**Staff Report to the
Southeast Town Design Review Committee
May 14, 2015**

**MPL2014-00039
SUB2015-00021
ITEM #1**

LAUREATE PARK NEIGHBORHOOD CENTER

PROPOSED CONCEPTUAL SITE PLAN

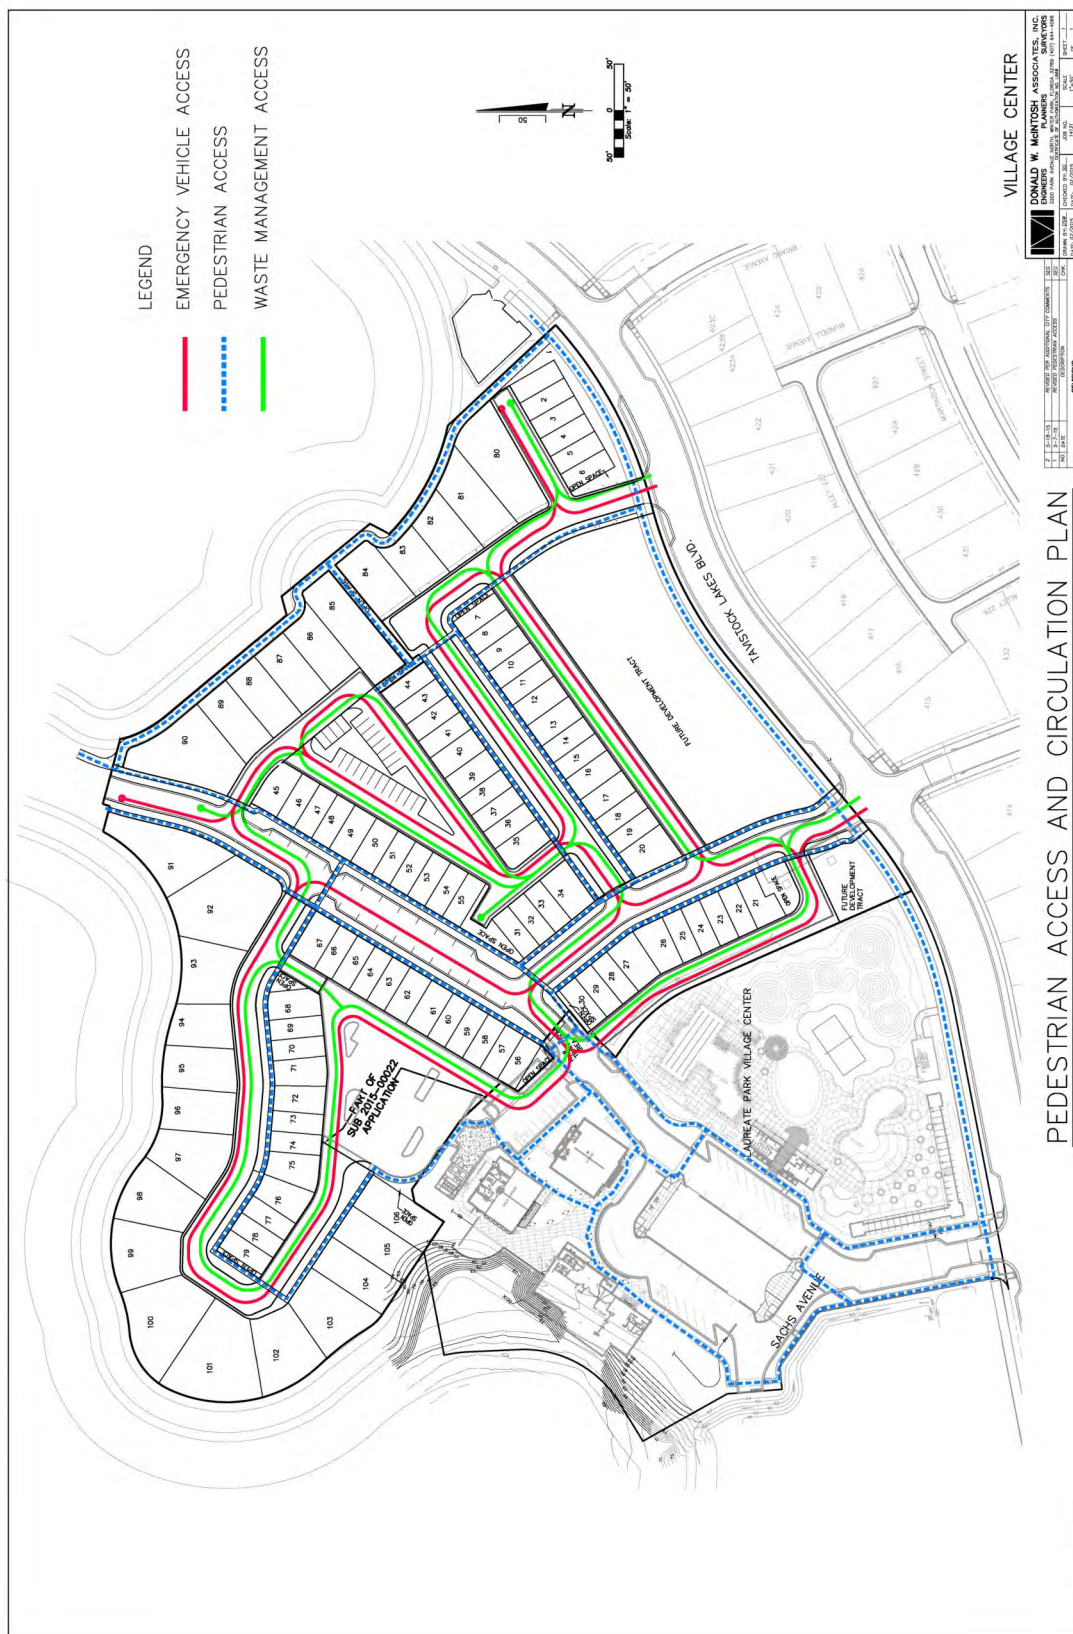
Updated
to show
public
versus
private
streets
per
SETDRC
approval

*Updated to
show the re-
vised pedes-
trian access
per SETDRC
approval*

PROPOSED STREET CROSS SECTIONS

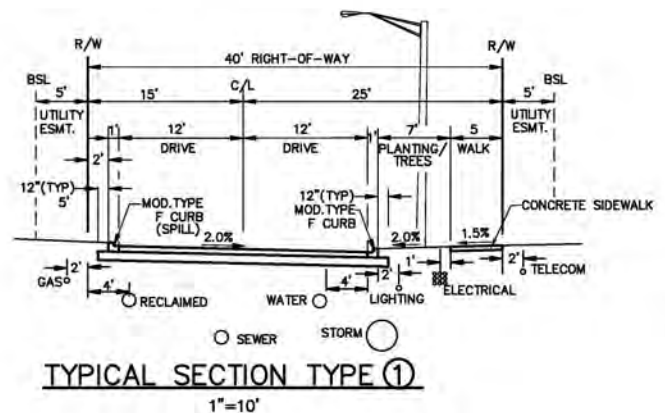
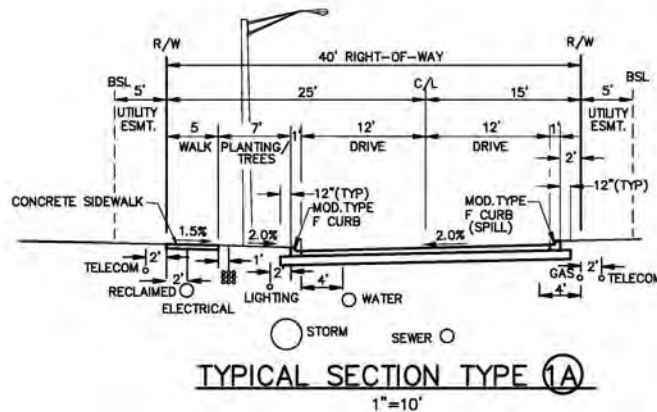
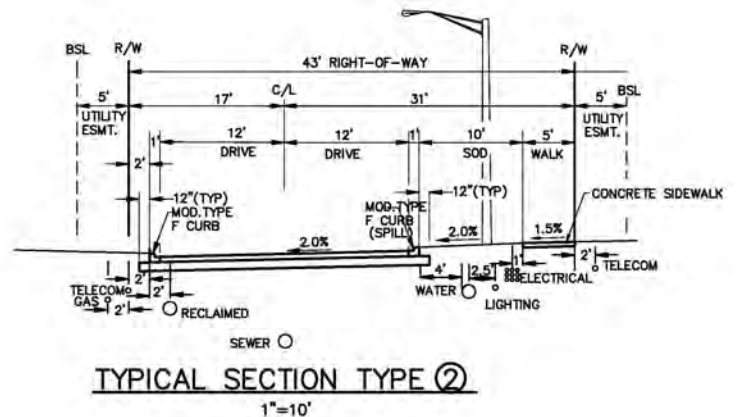
Typical Section Type 1 was updated per SETDRC approval.

PROPOSED STREET CROSS SECTIONS

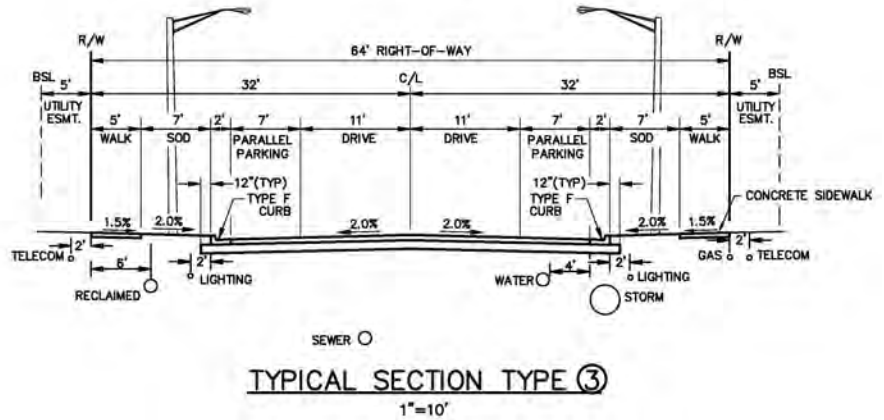
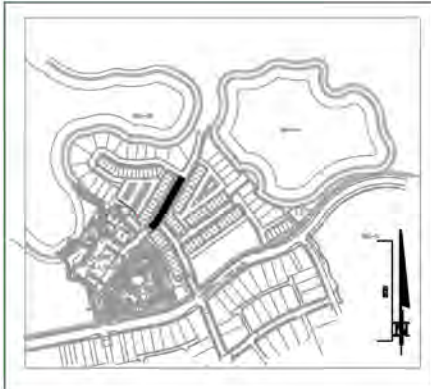
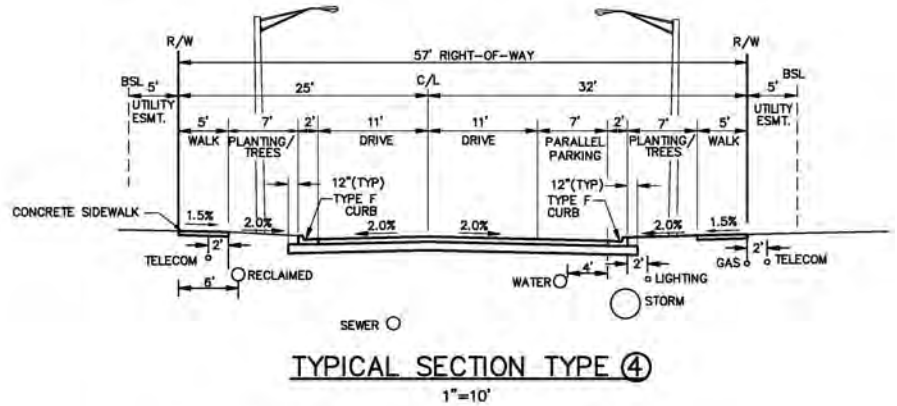
Typical Section Type 4 was updated per SETDRC approval.

PROPOSED STREET CROSS SECTIONS

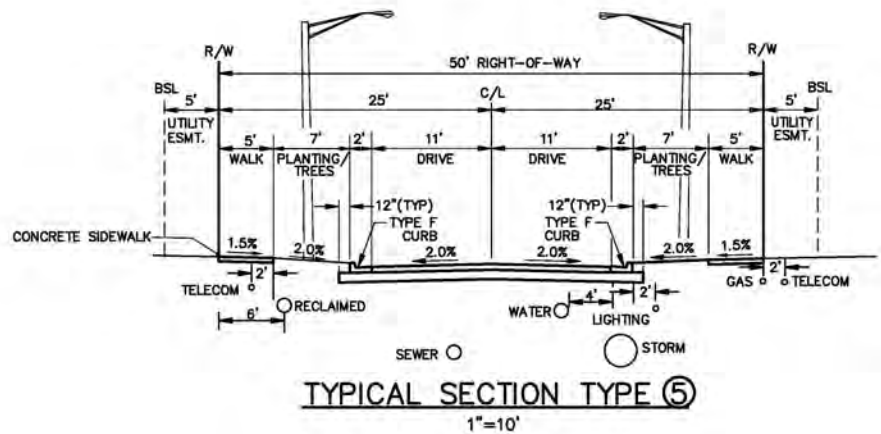
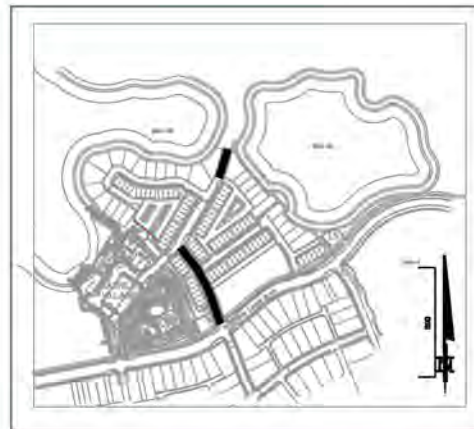
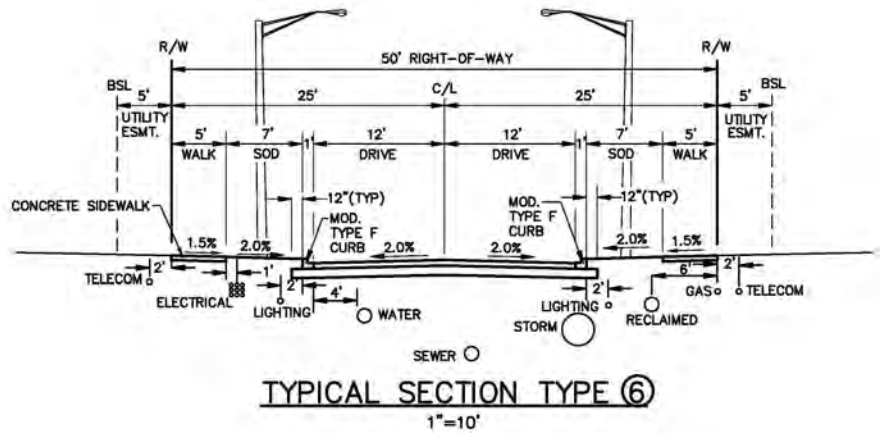
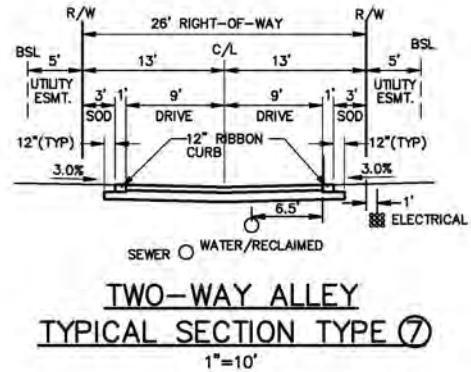
Typical Section Type 5 was updated per SETDRC approval.

PROPOSED WATER/SEWER/RECLAIMED EXHIBIT

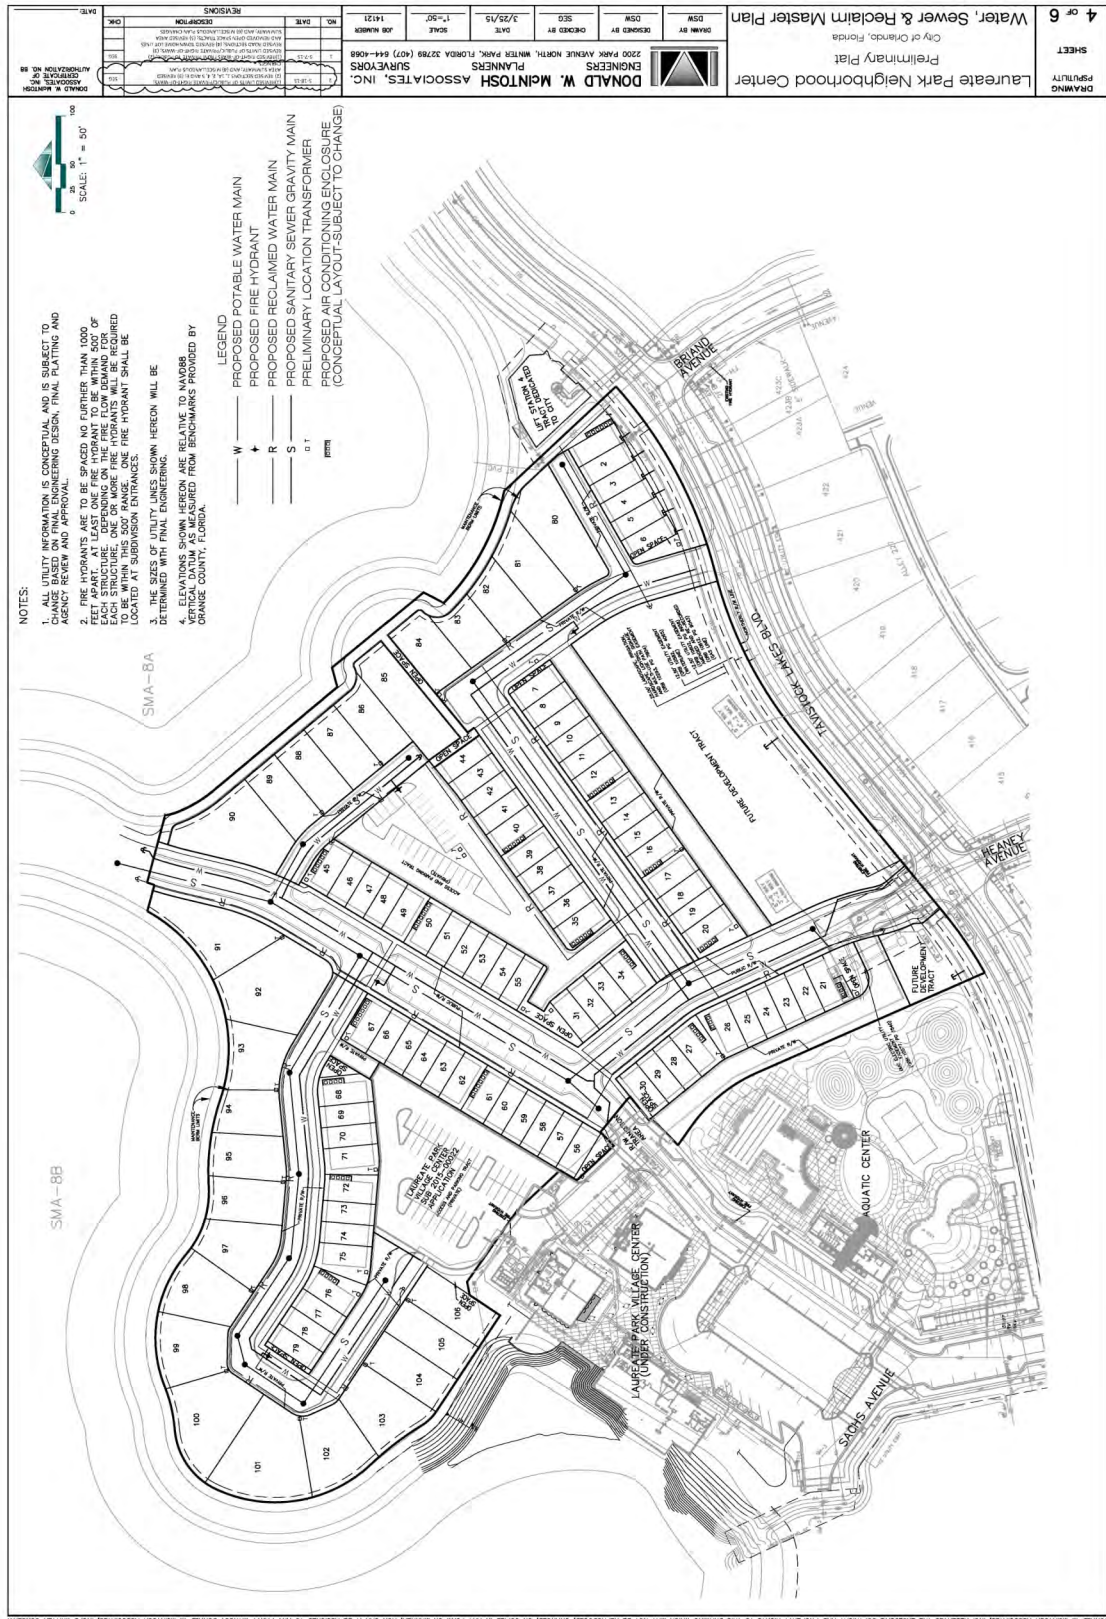
Updated to
show the re-
vised public
versus private
streets per
SETDRC ap-
proval

PROPOSED STORMWATER EXHIBIT

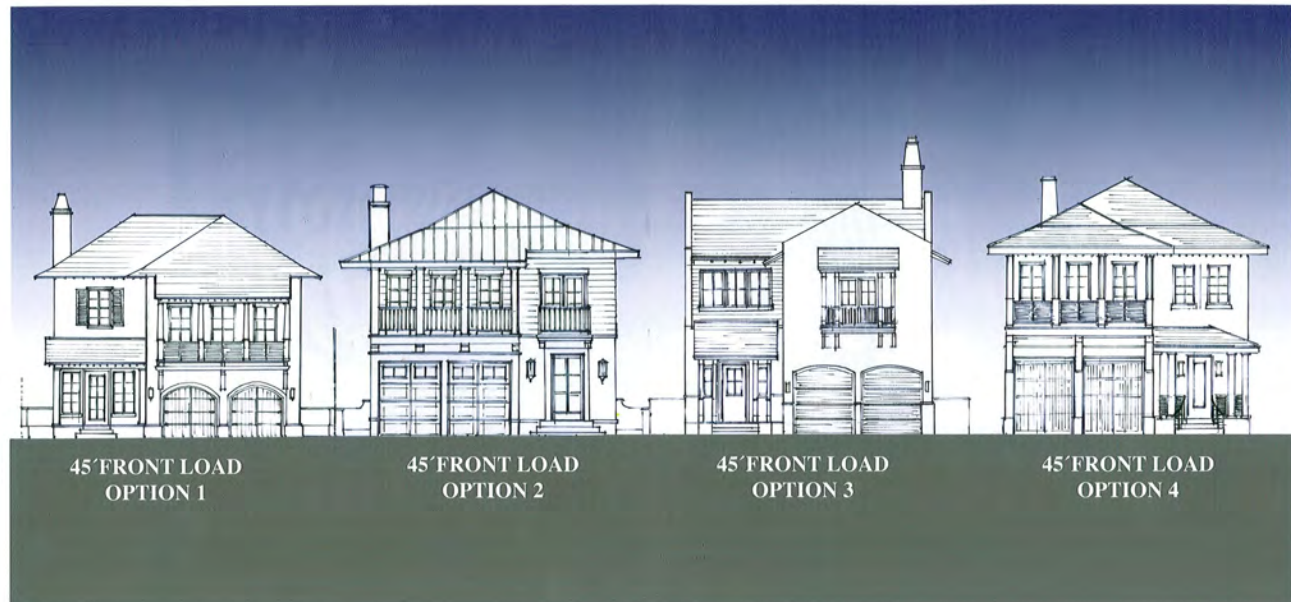
Updated to show the revised public versus private streets per SETDRC approval

PRELIMINARY PLAT

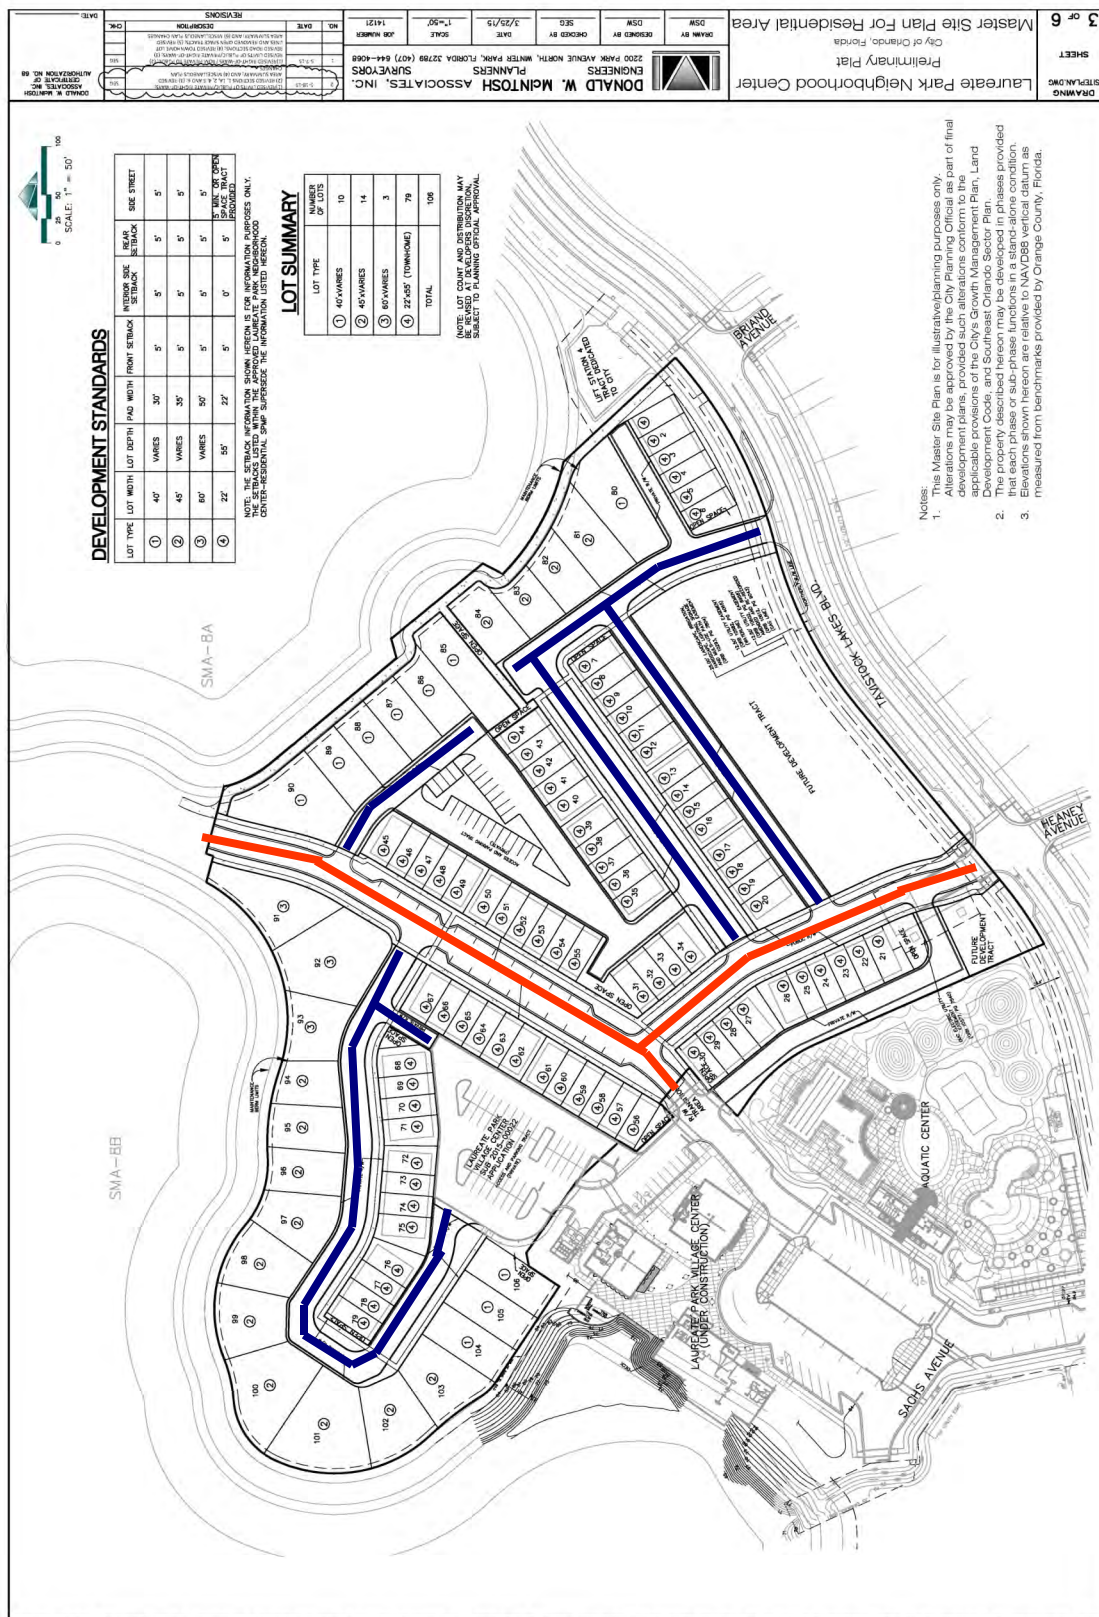
Updated to show the revised public versus private streets per SETDRC approval. Private street are highlighted in blue and public streets are highlighted in red.

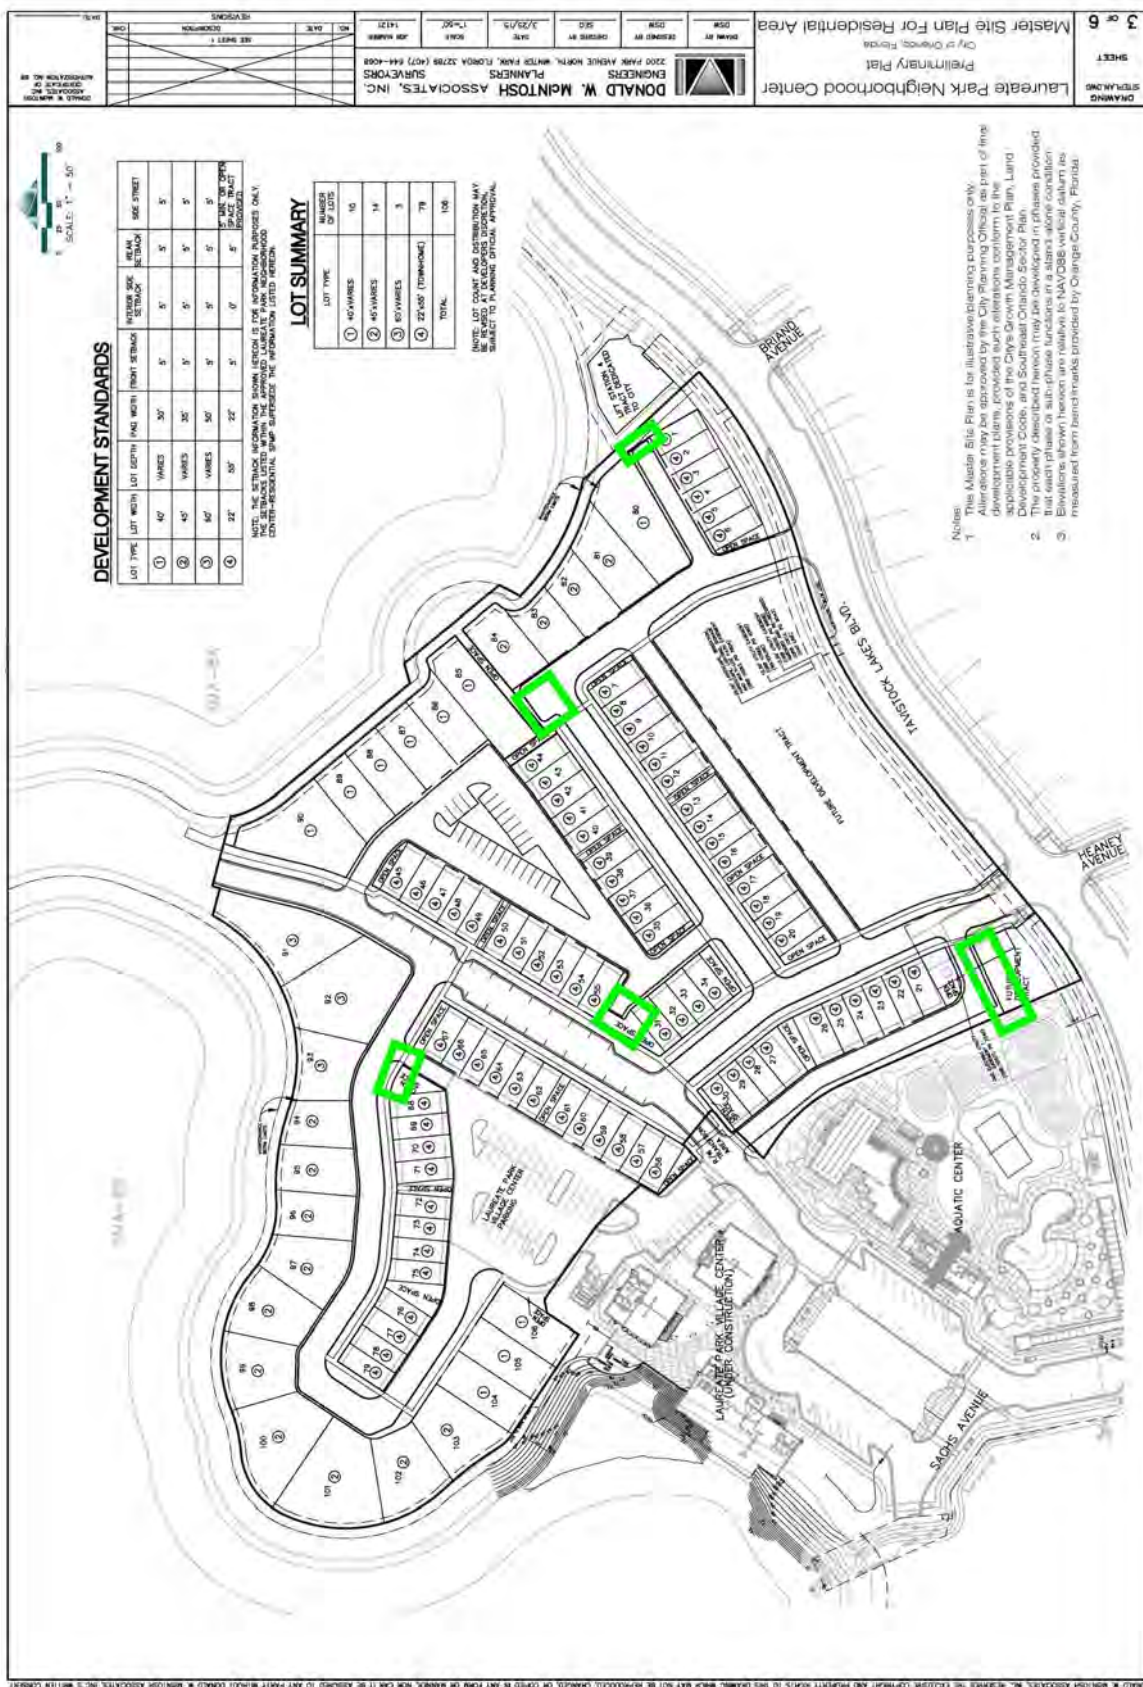
- a. Screen walls shall be provided between Lot 31 and Lot 55 to screen the alley from the street. The wall shall not be located in front of the principal façade of the building on lot 55, and shall turn toward Lot 31 to screen the alley. Wall shall be solid for up to 3 feet and no more than 60% opaque up to 5 feet. Pedestrian access or gate may be provided.

- b. Screen walls shall be provided in the open spaces adjacent to Lot 67 and Lot 68 to screen the alley from the street. Wall shall be solid for up to 3 feet and no more than 60% opaque up to 5 feet.

- c. Screen wall shall be provided at the end of the street adjacent to Lot 85 and Lot 84. Wall shall be solid for up to 3 feet and no more than 60% opaque up to 5 feet.

- d. Screen wall shall be provided at the end of the street adjacent to Lot 80 and townhome Lot 1, between the alley and the pedestrian trail. Wall shall be solid for up to 3 feet and no more than 60% opaque up to 5 feet. Pedestrian access or gate may be provided.

- e. Screen wall shall be provided along the south side of the alley adjacent to the “future development tract” near lot 21 and the OUC easement to screen the alley from Tavistock Lakes Blvd and future development. Wall shall be solid for up to 3 feet and no more than 60% opaque up to 5 feet.

- f. See the Screen Wall Exhibit on Page 36 for exact locations.
